Access Compliance Report

Public Rights-of-Way

(Curb Ramps)

Intersection ID: N/A	Main Street: S BREVARD ST	Cross Street: E 3RD ST	Location: S
ADA ID: 16217F4A8F54	Ramp Type: Perp	Initial Pass/Fail: Fail	Overall Compliance: No
			Severity Score: 22.5
Codes/Mitigation Info/Possible Solution		Field Measurements/Component Compliance

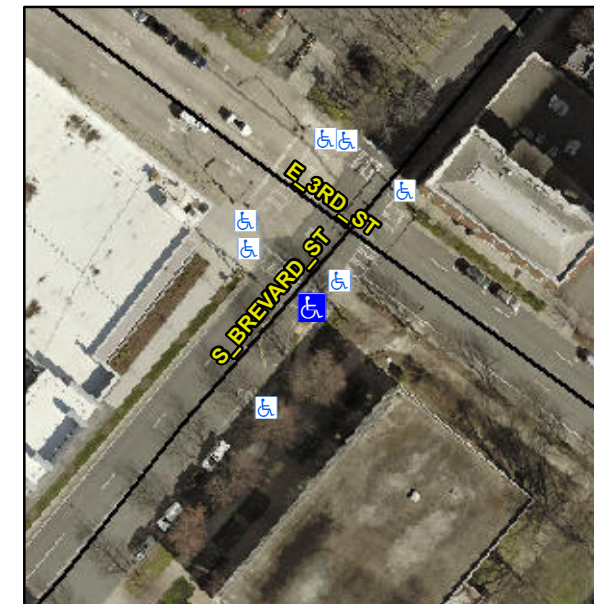
R304.5.1, R304.2.2, R304.5.3

Compliance	Description	Data	Compliance	Description	Data
N/A	Ramp Length (in)	72.0	No	Ramp Slope (%)	10.7
No	Ramp Width (in)	45.0	No	Ramp XSlope (%)	2.3
N/A	Flare Type LT	N/A	N/A	Flare Type RT	N/A
N/A	Flare Slope LT (%)	N/A	N/A	Flare Slope RT (%)	N/A
N/A	Flare Traversable LT?	No	N/A	Flare Traversable RT?	No
N/A	Landing Length (in)	N/A	N/A	DWS Provided?	N/A
N/A	Landing Width (in)	N/A	N/A	DWS Contrast?	N/A
N/A	Landing Slope (%)	N/A	N/A	DWS Length (in)	N/A
N/A	Landing X Slope (%)	N/A	N/A	DWS Full Width?	N/A
N/A	Landing Curb? (Y/N)	N/A	N/A	DWS Offset (in)	N/A
N/A	Shared Landing?	N/A			
N/A	Gutter Ponding?	N/A	N/A	Gutter Slope (%)	N/A
N/A	Gutter Lip Ht (in)	N/A	N/A	Gutter X Slope (%)	N/A
N/A	Painted X Walk1?	Yes	N/A	Painted X Walk2?	N/A
	X Walk 1 Direction	To NW		X Walk 2 Direction	N/A
N/A	X Walk 1 Width (in)	111.0	N/A	X Walk 2 Width (in)	N/A
	X Walk 1 Slope (%)	1.8		X Walk 2 Slope (%)	N/A
	X Walk 1 X Slope (%)	0.9		X Walk 2 X Slope (%)	N/A

Remove & Replace Entire Ramp.
